**Explanation of Significant Differences  
for the Record of Decision for Interim Action  
to Remove Fuel and Flush Salts  
from the Molten Salt Reactor Experiment Facility  
at the Oak Ridge National Laboratory,  
Oak Ridge, Tennessee**

U.S. Department of Energy (DOE)  
Oak Ridge Reservation (ORR)  
Molten Salt Reactor Experiment Facility (MSRE)—Building 7503  
MSRE Decontamination and Decommissioning (D&D) Support  
Oak Ridge National Laboratory (ORNL)  
Oak Ridge, Tennessee  
CERCLIS ID TN1890090003

DOE/OR/01-2088&D2

Fig. 1. Graphic comparison of approved ROD and ESD remedies.

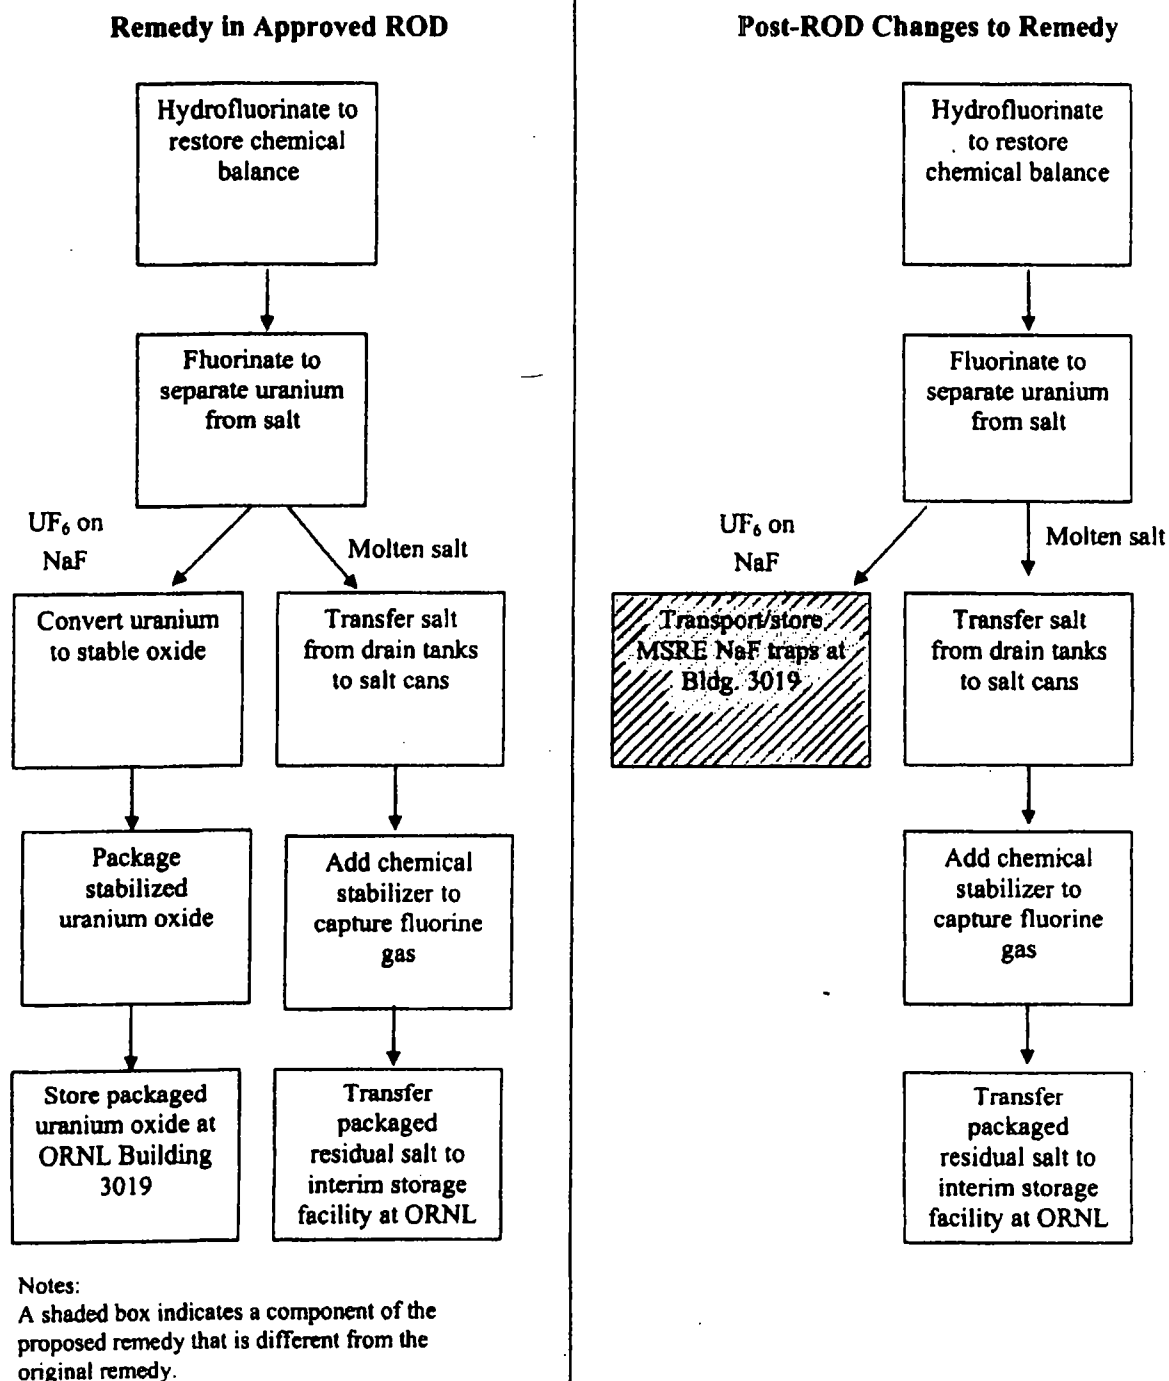
**Scope.** A side-by-side comparison of the original and proposed remedy components is given in Fig. 1 to clearly display the significant differences with regard to scope. A shaded box indicates a component of the proposed remedy that is different from the original remedy.

The original and proposed remedy components differ only after the point in the process where the uranium has been separated from the salt by fluorination and then collected on NaF traps.

This ESD deletes the ROD requirement to convert the MSRE separated  $^{233}\text{U}$  to an oxide. Storage of the MSRE  $^{233}\text{U}$  in Building 3019 completes all MSRE CERCLA obligations for this material. The MSRE  $^{233}\text{U}$  would then be managed under the same authority as the remainder of the 3019 material. This post-ROD change impacts the scope and cost of the MSRE remedy.
